Enclosed please find the comments of Catskill Mountainkeeper, Delaware Riverkeeper Network, Earthjustice, the Natural Resources Defense Council and Riverkeeper on the Revised Draft Supplemental Generic Environmental Impact Statement on the Oil, Gas and Solution Mining Regulatory Program, Well Permit Issuance for Horizontal Drilling and High-Volume Hydraulic Fracturing to Develop the Marcellus Shale and Other Low-Permeability Reservoirs, issued September 7, 2011, and draft regulations (Proposed Express Terms 6 NYCRR Parts 52, 190, 550-556, 560, 750.1, and 750.3), issued September 28, 2011.

RE: Technical Comments Summary Report: Expert Team Review of the 2011 Revised Draft SGEIS on the Oil, Gas and Solution Mining Regulatory Program and Proposed High-Volume Hydraulic Fracturing Regulations

Photo 5.7 from SGEIS
Annotated by HCLLC
Distances shown by arrows drawn to scale

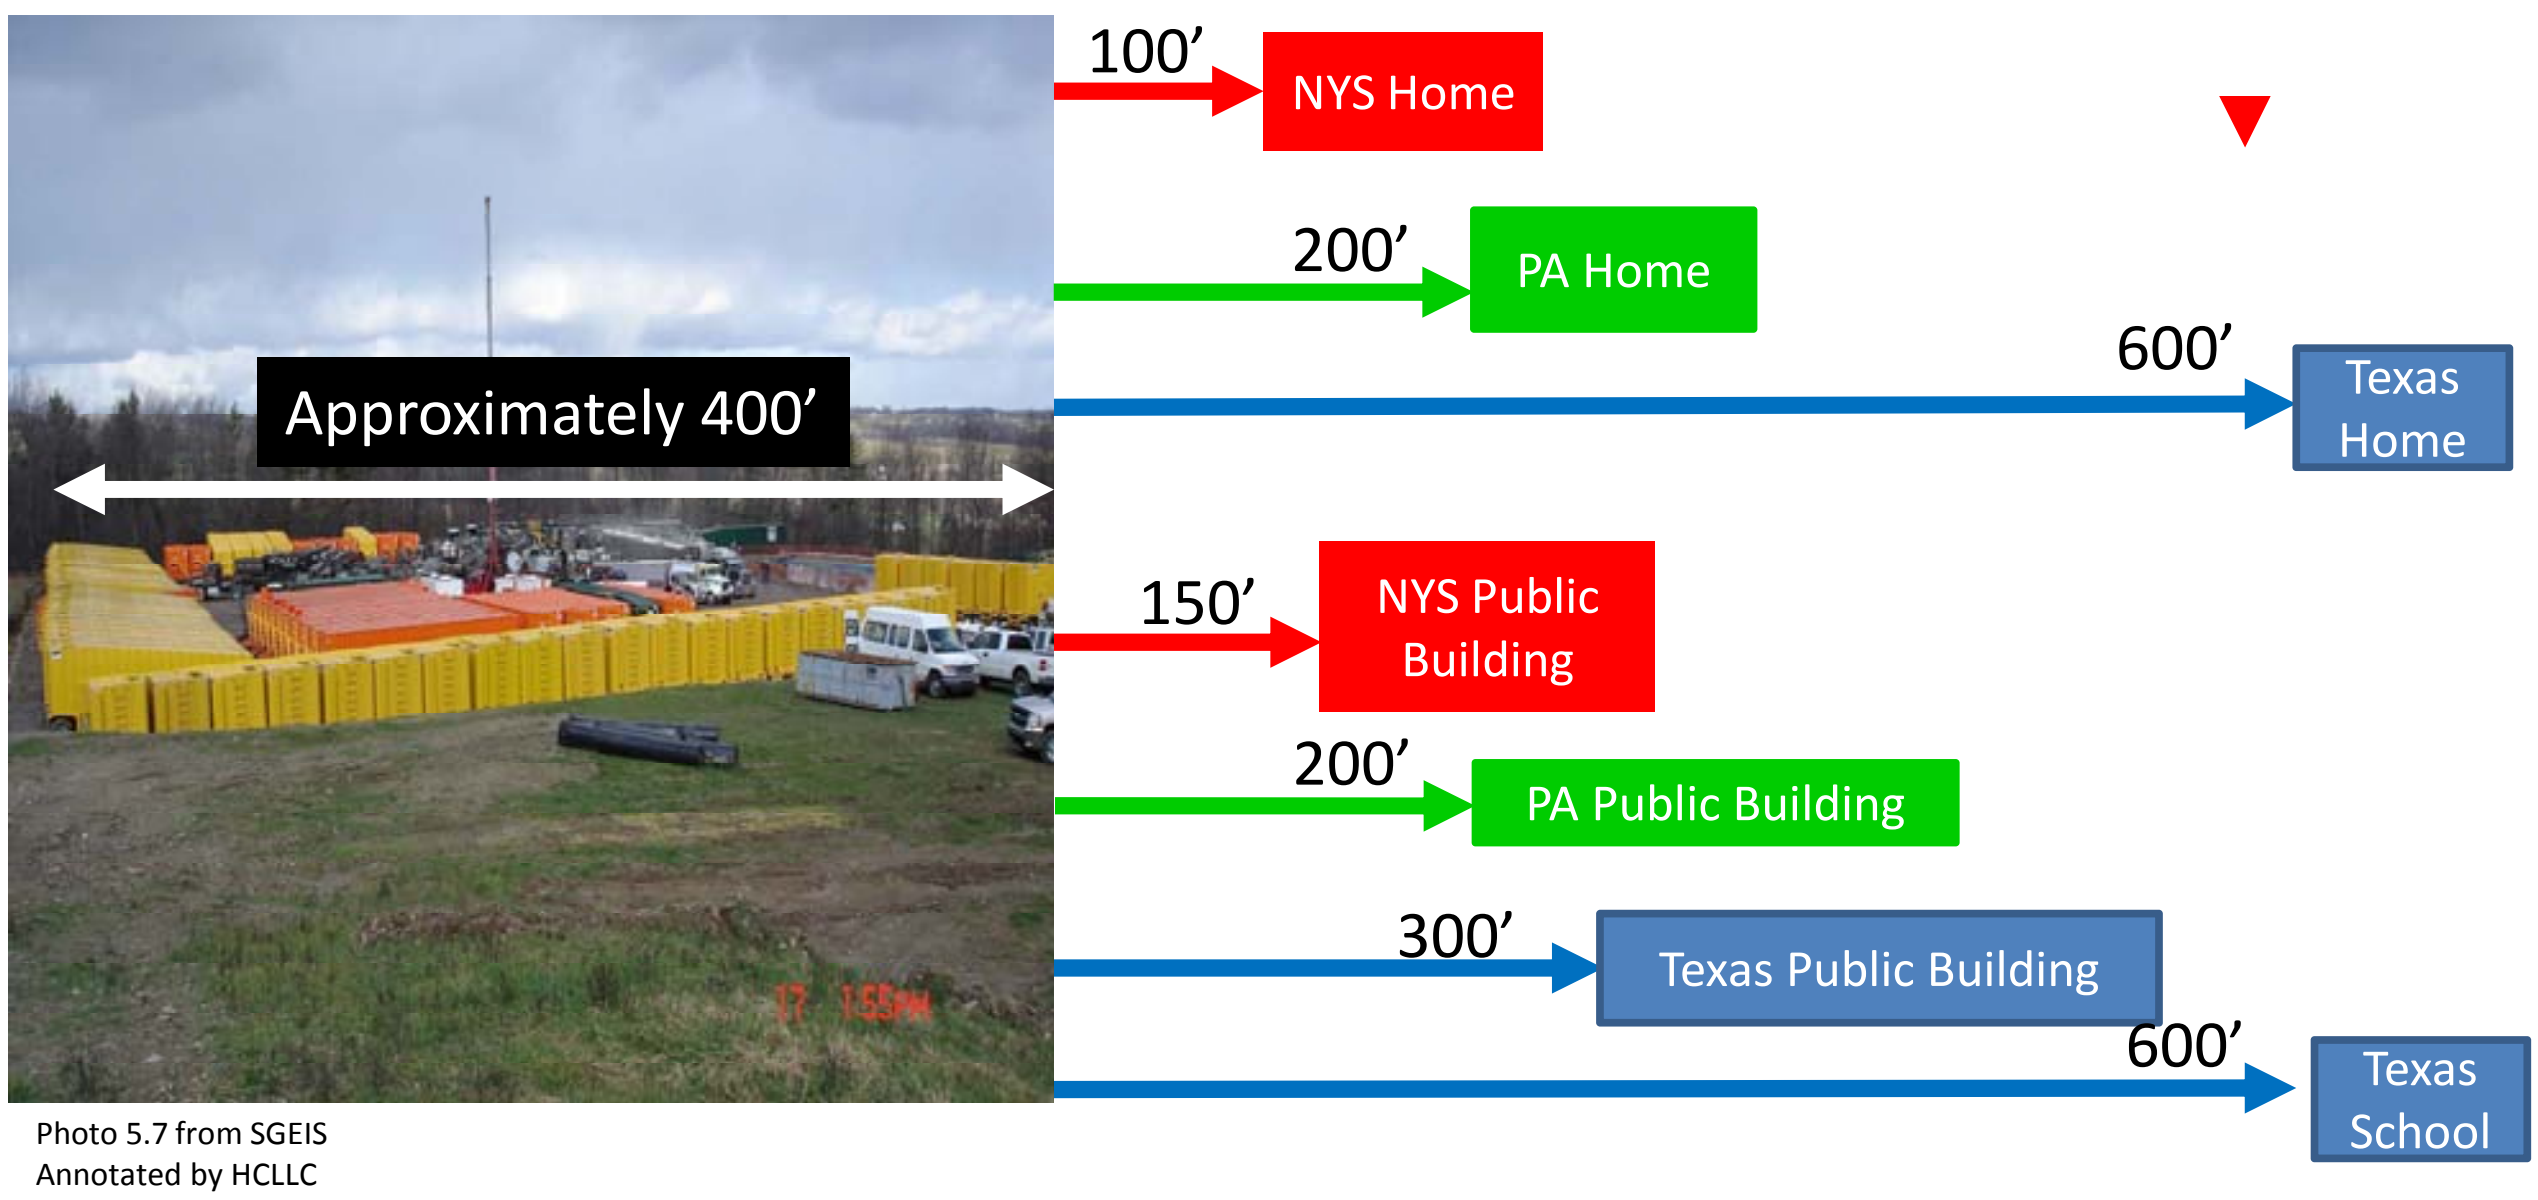
The potential radius of impact for explosions, fire, and other industrial hazards should be considered in the RDSGEIS and proposed HVHF regulations. For example, Fort Worth Texas uses the International Fire Code as the basis for its minimum 600’ setback from shale gas drilling operations. The figure below shows how the HVHF regulations setback distance requirements are significantly shorter and thus less protective than the requirements in other locations.

Figure 4.2, RDSGEIS, Annotated by HCLLC

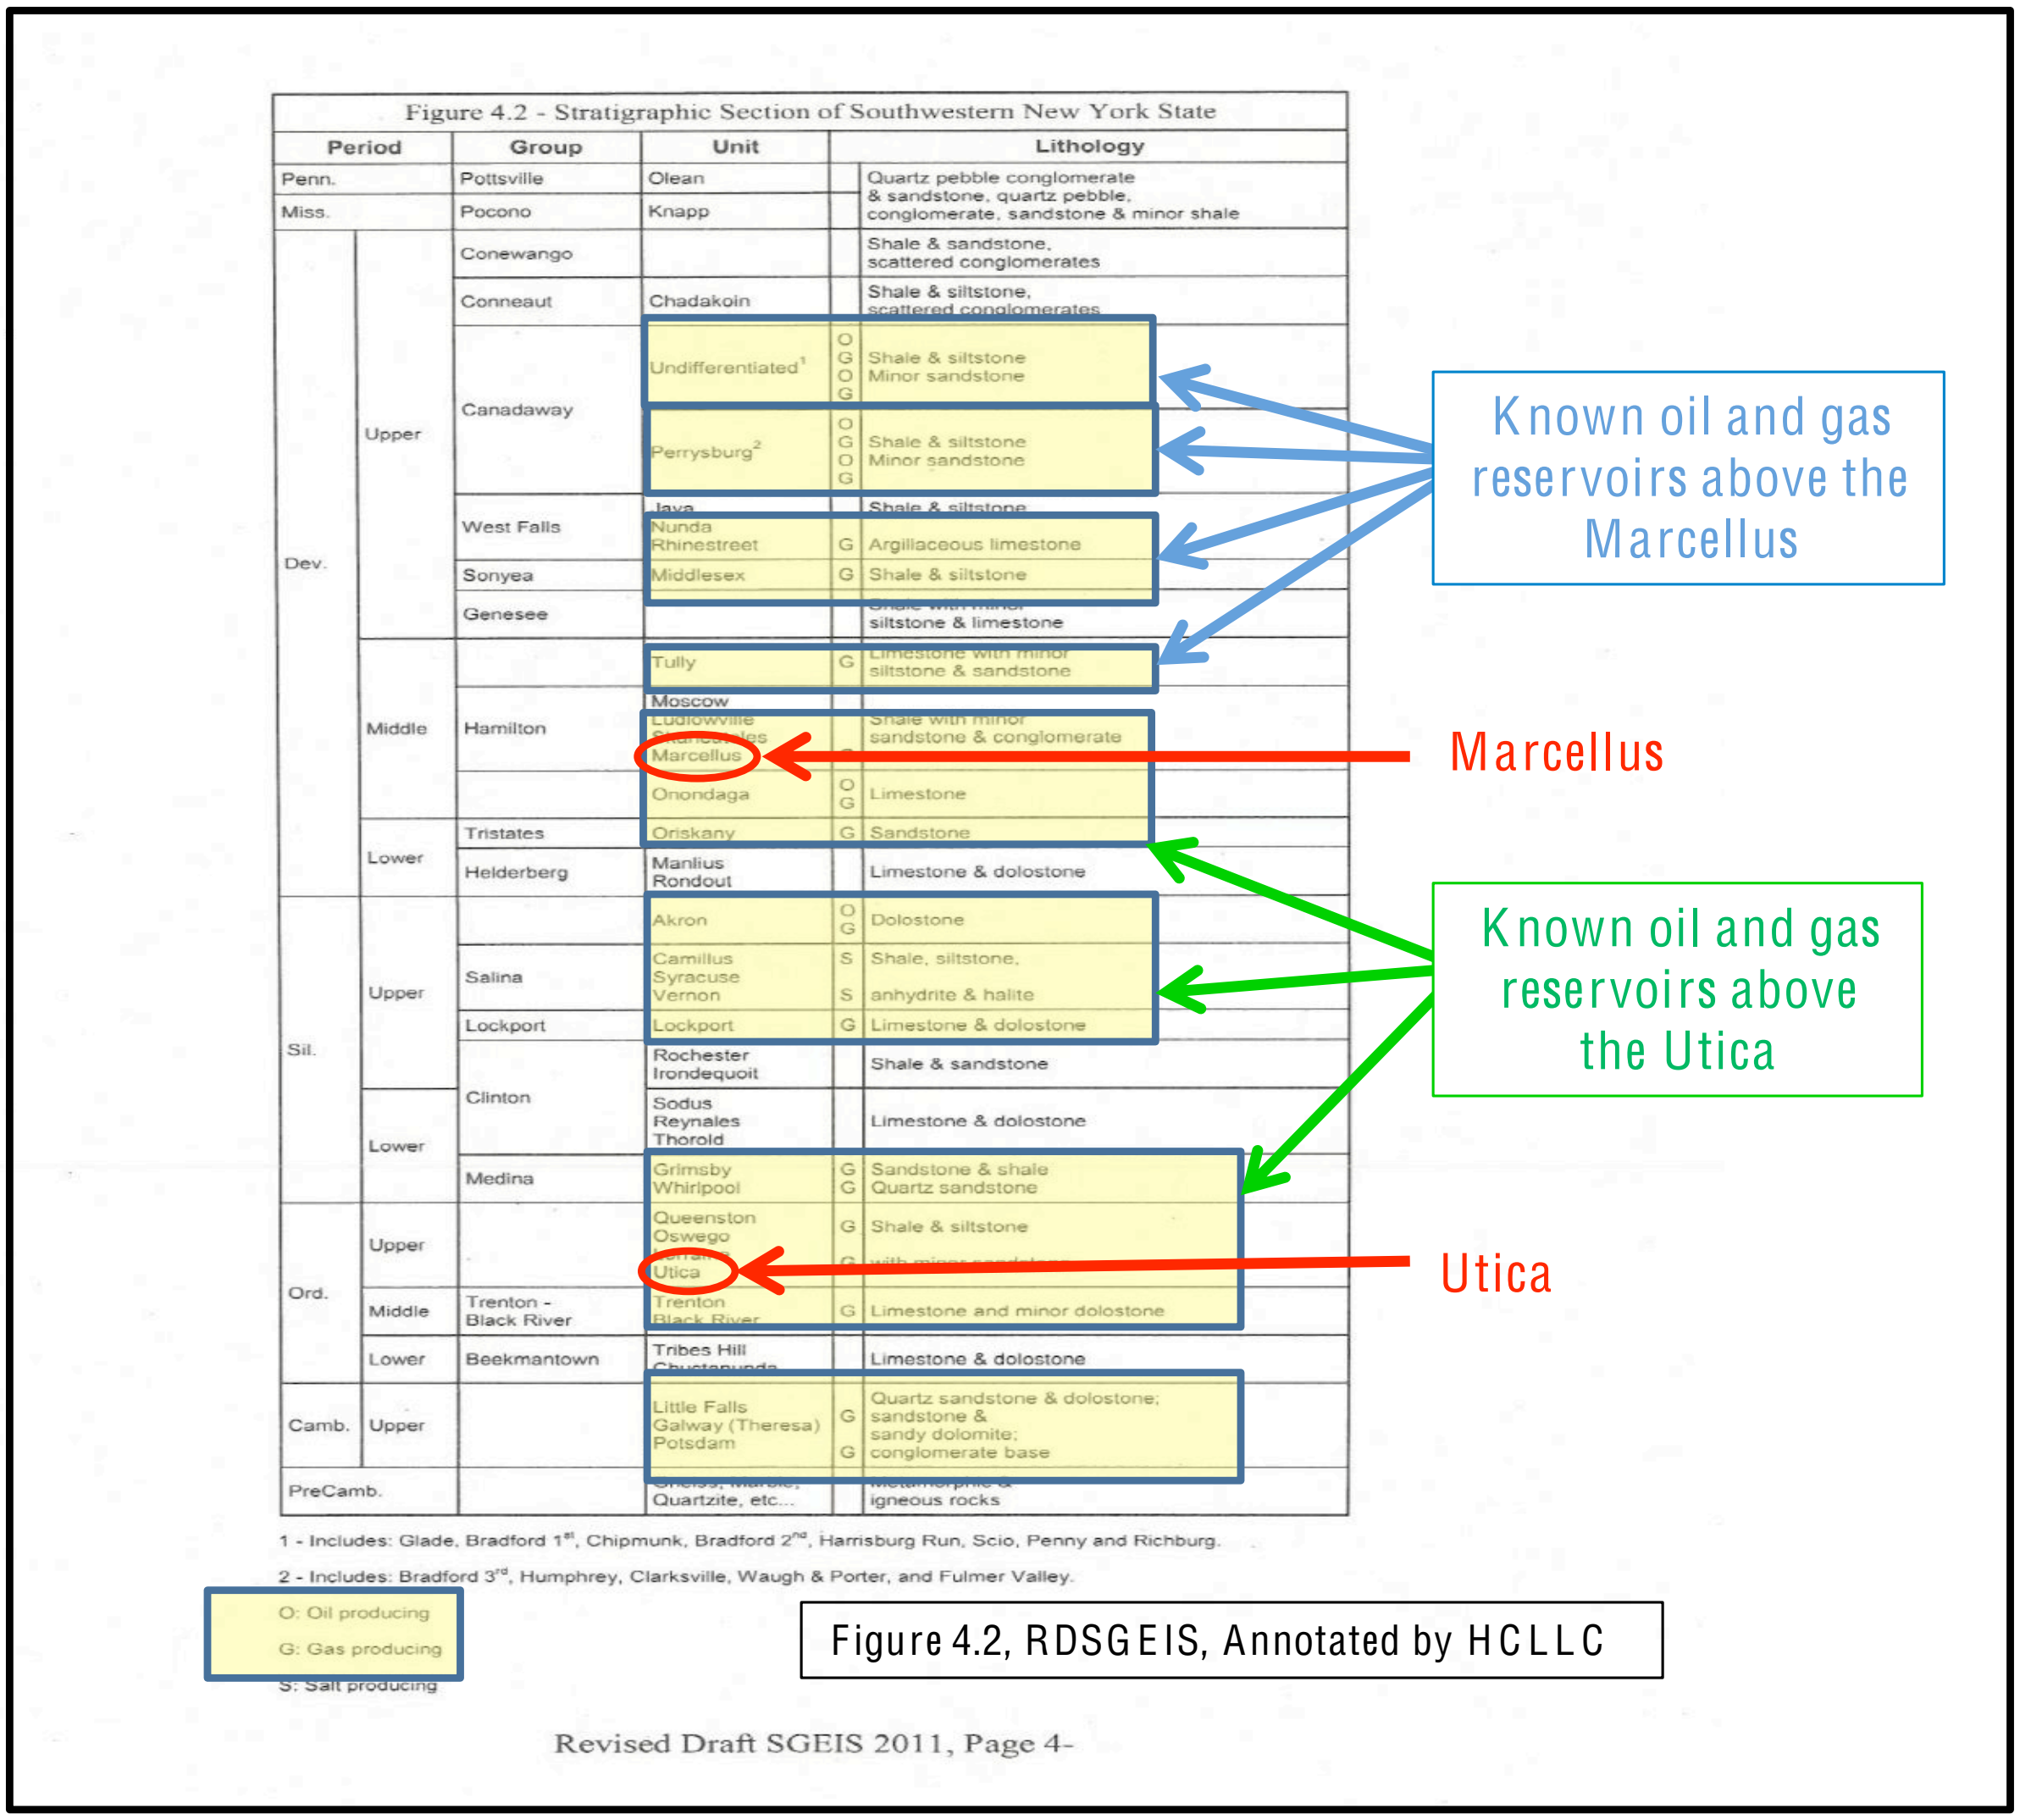
Figure 4.2 of the RDSGEIS[6] includes a stratigraphic section showing existing known oil and gas intervals above the Marcellus and Utica Shales, including numerous shale and other low-permeability formations that are known to exist, that were not examined in the SGEIS.

The 2011 RDSGEIS provided several useful maps and a stratigraphic section that aid in understanding the overlap of NYS' oil and gas production intervals. Figure 4.2 includes a Stratigraphic Section of Southwestern NYS that shows oil is produced from the Upper Devonian, at shallower depths than the Marcellus Shale, meaning that wells drilled in this region may encounter oil before penetrating the Marcellus. An annotated version of Figure 4.2 is also shown in Chapter 2 of this report. Figures 4.8 and 4.9 indicate that there is an overlap of current oil production with possible Marcellus Shale development in Cattaraugus, Allegany, Chautauqua, and Steuben counties.

Plot from Fisher 2010 Cited in 2011 rdSGEIS; annotated by HCLLC with additional red, green, and magenta font information.

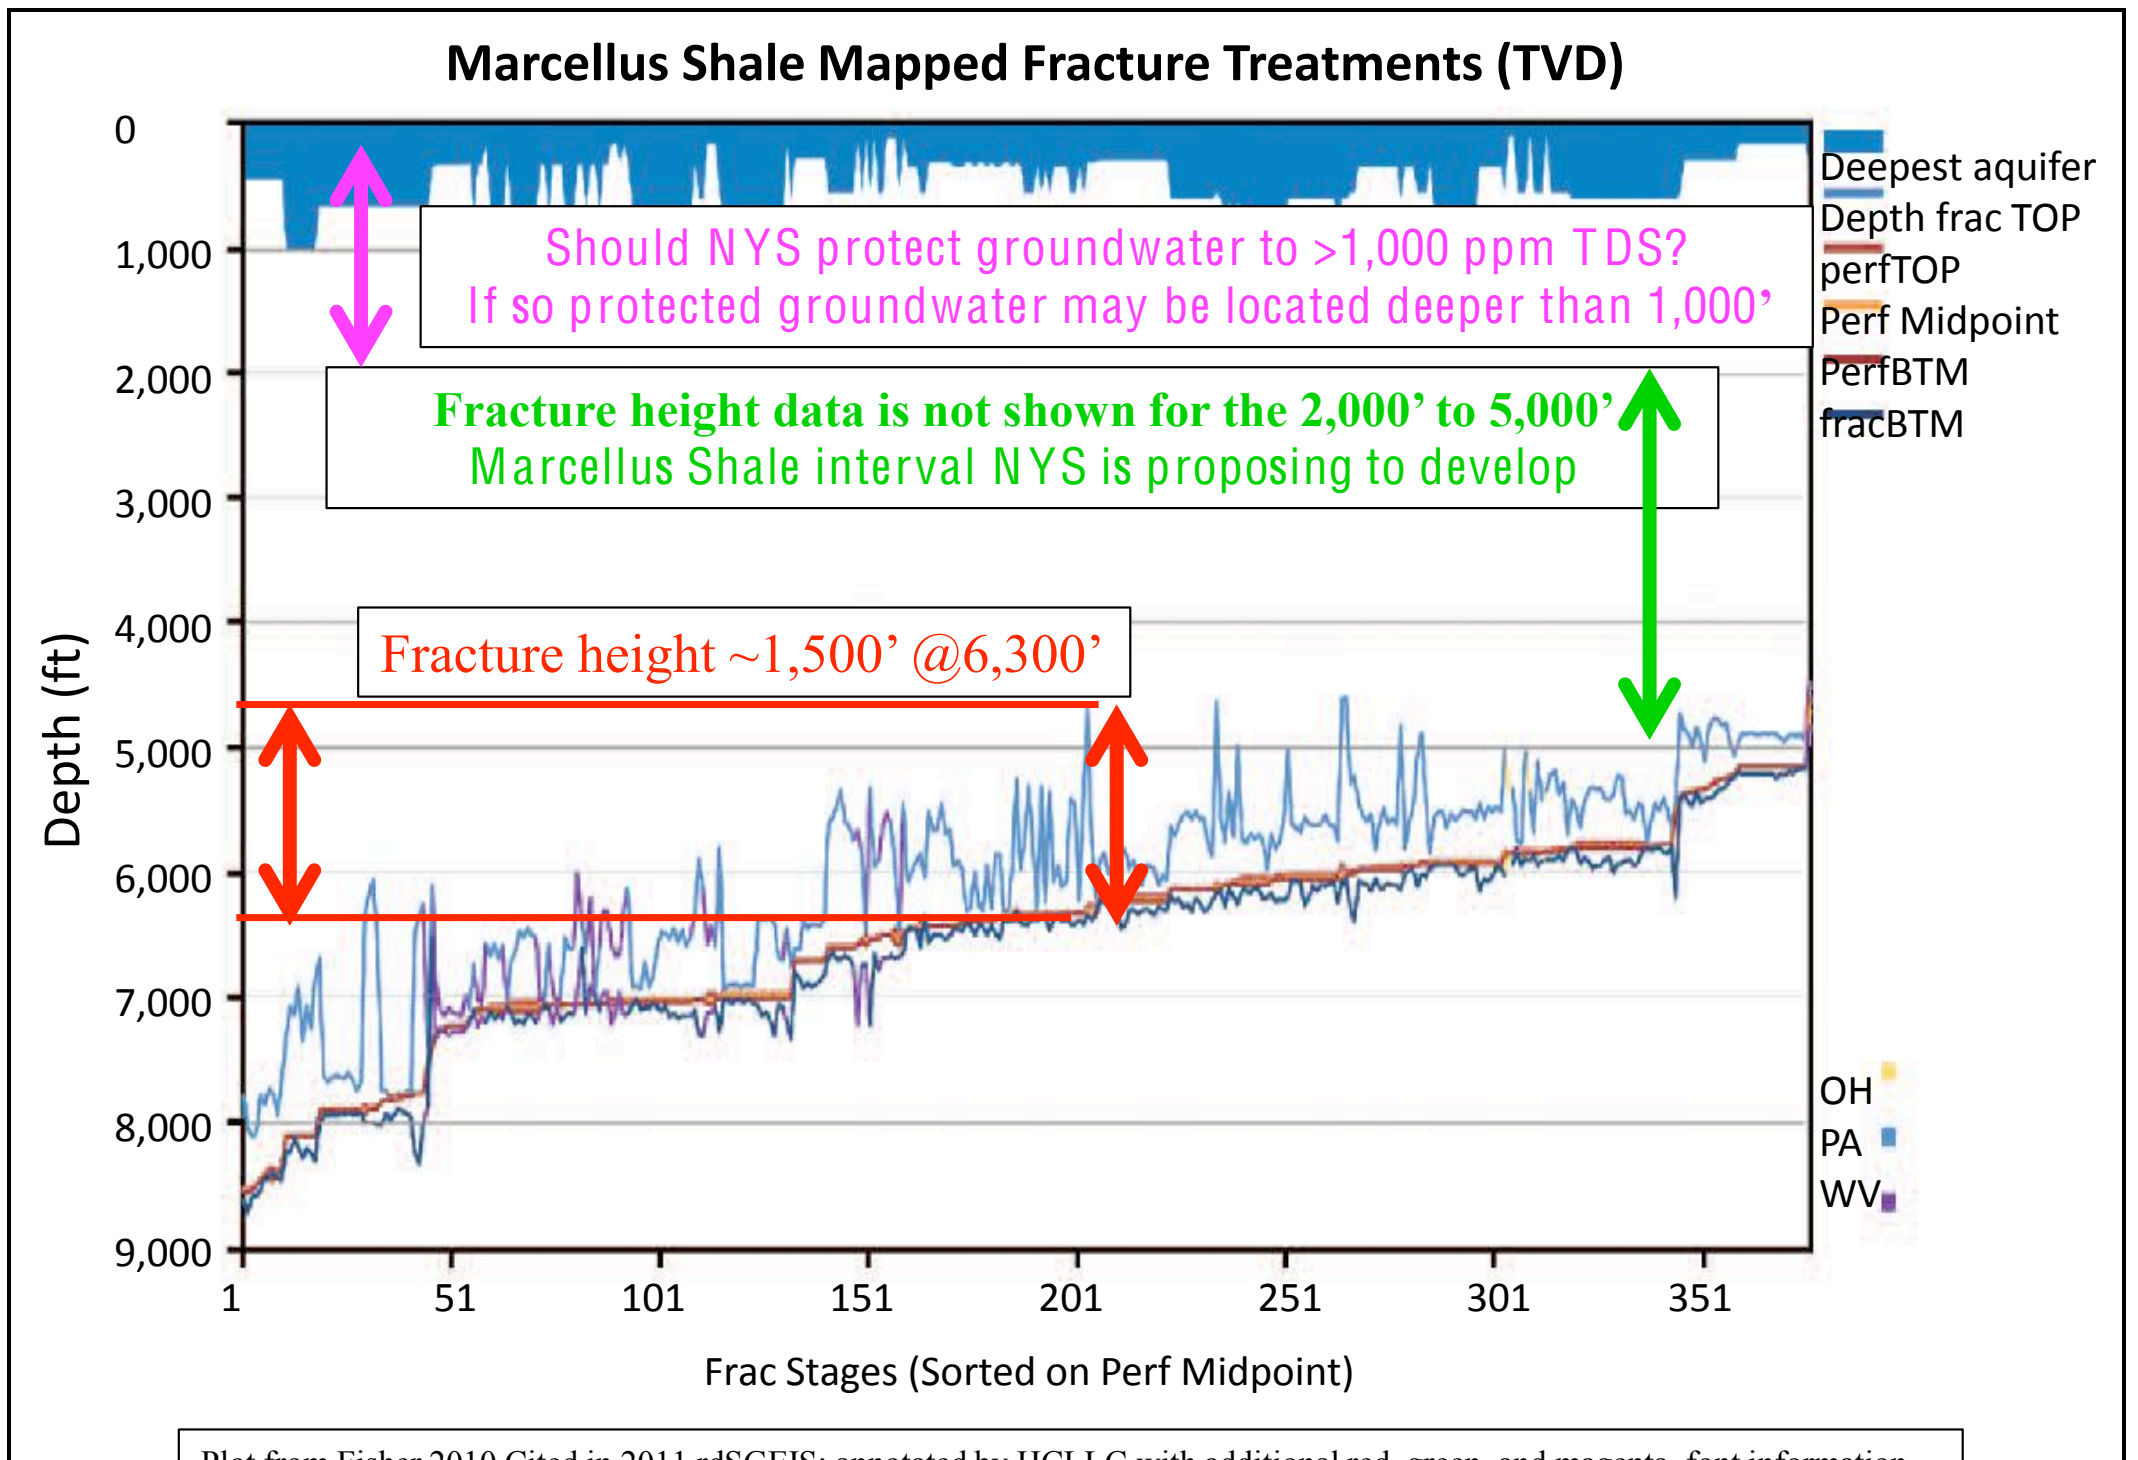
The Marcellus fracture height figure shown in the American Oil & Gas Reporter is provided below; HCLLC annotated it to identify additional evaluation that is needed for NYS.

The use of vertical offset limits to separate hydrocarbon recovery operations from protected aquifers is a reasonable approach, but it must be scientifically and technical supported. While it is possible that a 1,000' vertical offset may potentially be sufficiently protective; the 2011 RDSGEIS does not provide sufficient scientific data or technical examination to support this recommended threshold.
